TRANSPORTATION ADVISORY COMMITTEE

Subject: Intersection of Mass Avenue/Mill Street/Jason Street

Date: May 9, 2013

RECOMMENDATIONS FOR IMPROVEMENTS AT MASSACHUSETTS AVENUE/MILL STREET/JASON STREET

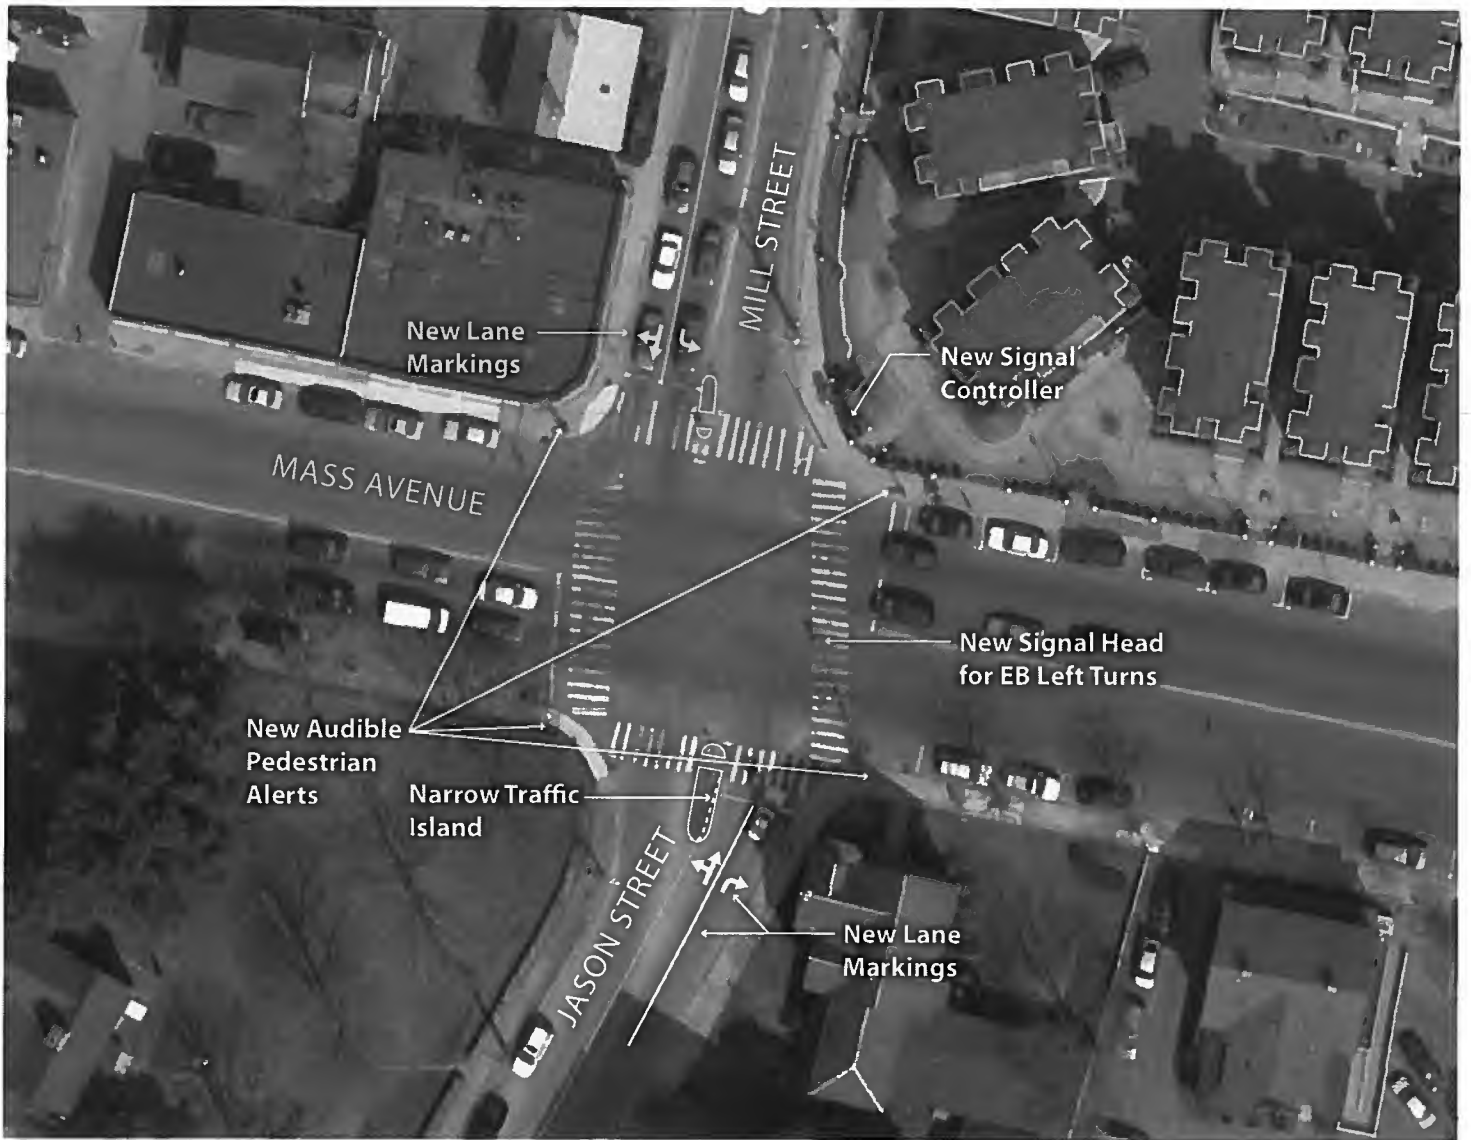
1. Modify Mill Street southbound to have an exclusive left turn lane and a shared through/right turn lane.
2. Modify Jason Street northbound to have an exclusive right turn lane and a shared left/through lane.

3. Add a new signal controller with split phasing so that the traffic from Mill Street and Jason Street run separately with no conflicts.
4. Provide a 3-second advance for pedestrians crossing Mass Avenue concurrently with vehicles turning right from Mill and Jason Streets.

5. Provide pedestrian countdown timers and local audible alerts for pedestrian crossings.
6. Slightly reduce the width of the Jason Street traffic island to accommodate two northbound approach lanes.

7. Provide a bi-modal green/yellow left arrow for Mass Avenue eastbound.
8. Coordinate with business owners on Mill Street to discuss prohibiting on-street parking during peak weekday periods to accommodate vehicle queuing.

The recommendations are shown in the attached figure.
